FIELD ENGINEERING BULLETINTITLE: CHANGING OPERATING-SPEED PAIR AND
MASTER BIAS OPERATION

DATE OF ISSUE 9/15/76

To change operating-speed pair and master bias operation for the ATR-100 Recorder/Reproducer.

Figure 1. Overlay panels, Audio Control PWA No. 5.

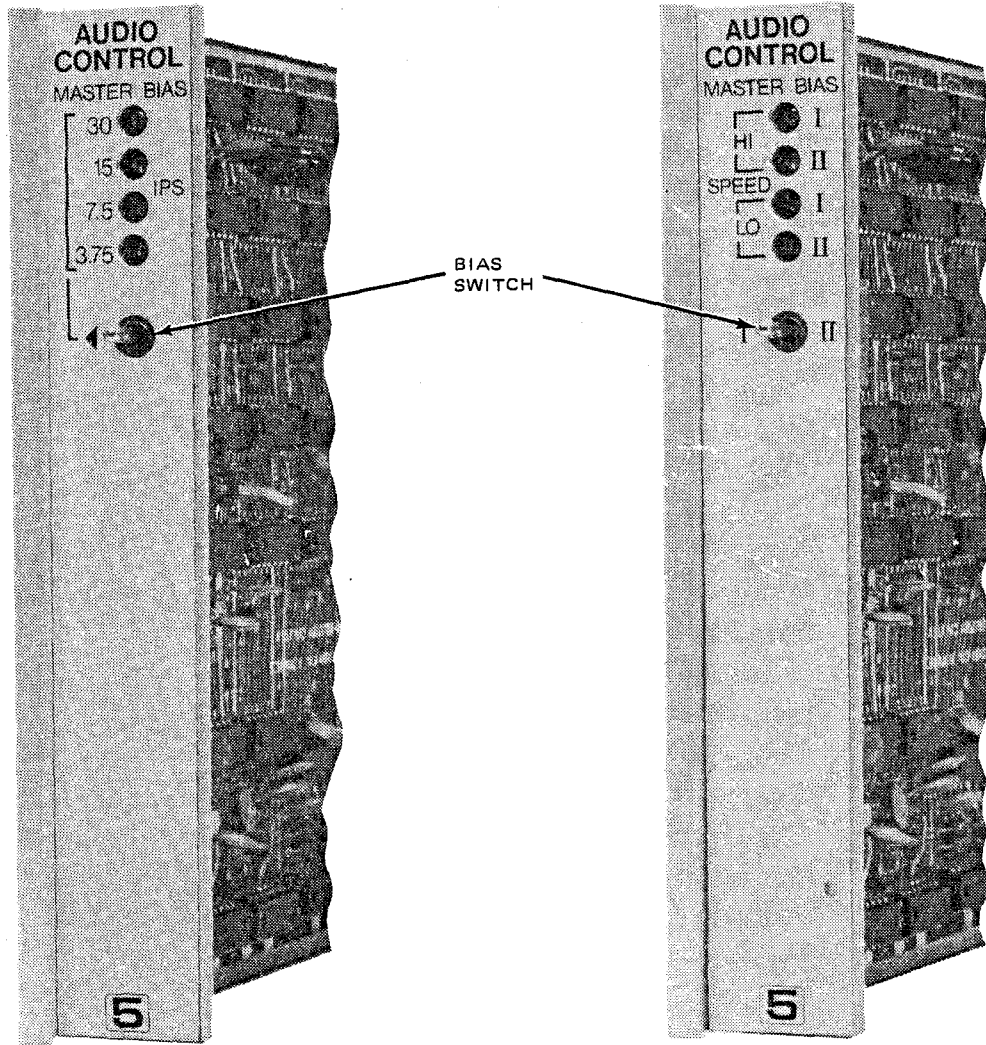
The jumper plugs on the audio control PWA no. 5 permit the user to program the ATR-100 for two-speed dual master bias operation or four-speed master bias operation. When the ATR-100 is programmed for two-speed dual master bias operation, a switch on the front panel of the audio control PWA no. 5 (Figure 1) enables the operator to select one of two different master bias levels for each of the two operating speeds. When the recorder is programmed for four-speed operation, the switch is permanently placed in the left-hand position and a single master bias level is provided for each speed. This master bias level is automatically switched for the speed selected on the transport control panel.

2. If two-speed overlay panel (Figure 1) is not in the front position on the PWA, remove front-panel screw, interchange overlay panels, and reinstall screw.
3. Position HI speed jumper J1 to the desired high speed 30, 15, or 7.5-in/s position (Figure 3).
4. Position LO speed jumper J2 to the desired low speed 15, 7.5, or 3.75-in/s position.
5. Position jumpers J3 and J4 to the S (stored) position. Reinstall audio control PWA no. 5.
6. For each new speed selected, perform the appropriate signal system alignment procedure indicated in this FEB.

1. With power off, remove audio control PWA no. 5 from the electronics assembly.
2. If four-speed overlay panel (Figure 1) is not in the front position on the PWA, remove front-panel screw, interchange overlay panels, and reinstall screw.
3. Position jumper J1 to the 30-in/s position (Figure 3).
4. Position jumper J2 to the 7.5-in/s position.
5. Position jumper J3 to the 15-in/s position.
6. Position jumper J4 to the 3.75-in/s position. Reinstall audio control PWA no. 5.
7. For each new speed selected, perform the appropriate signal system alignment procedure indicated in this FEB.

Figure 2. Speed Selection Jumpers, Padnet PWA.

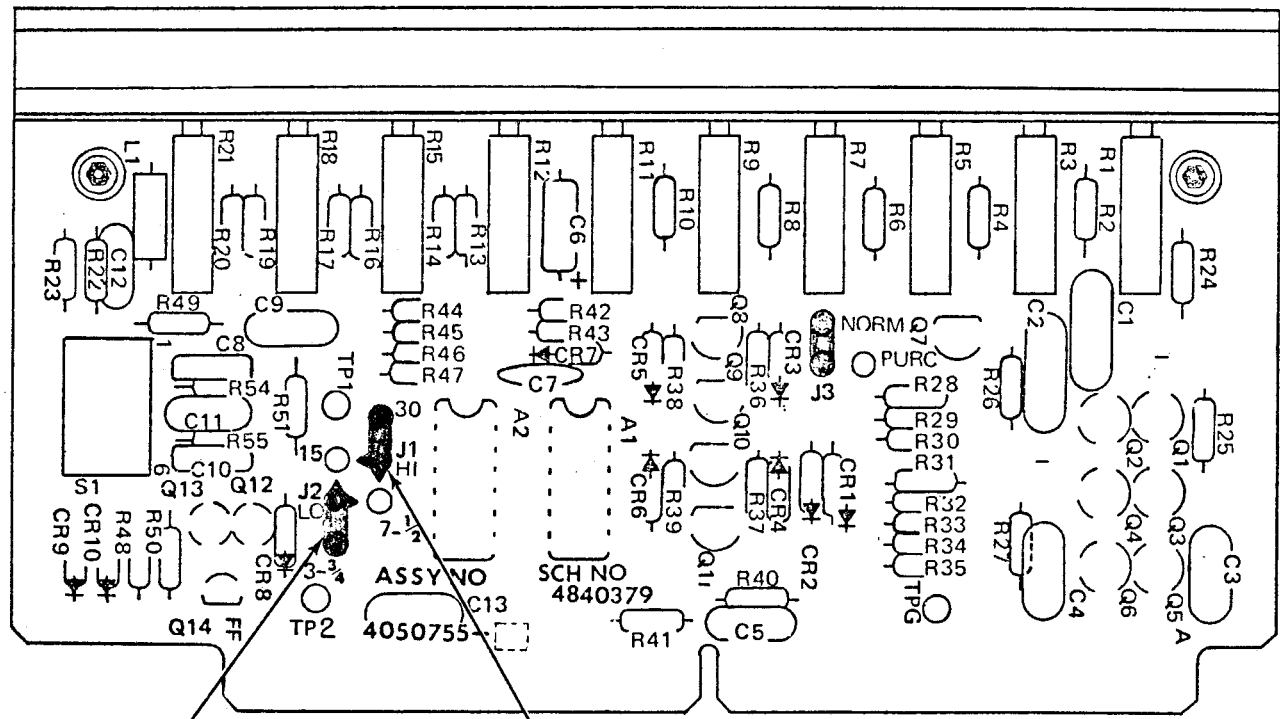
1. With power off, remove the PADNET PWA for each channel from the electronics assembly.
2. Position HI speed jumper J1 to the desired high speed 30, 15, or 7.5-in/s position (Figure 2).
3. Position LO speed jumper J2 to the desired low speed 15, 7.5, or 3.75-in/s position. Reinstall PADNET PWA (s).
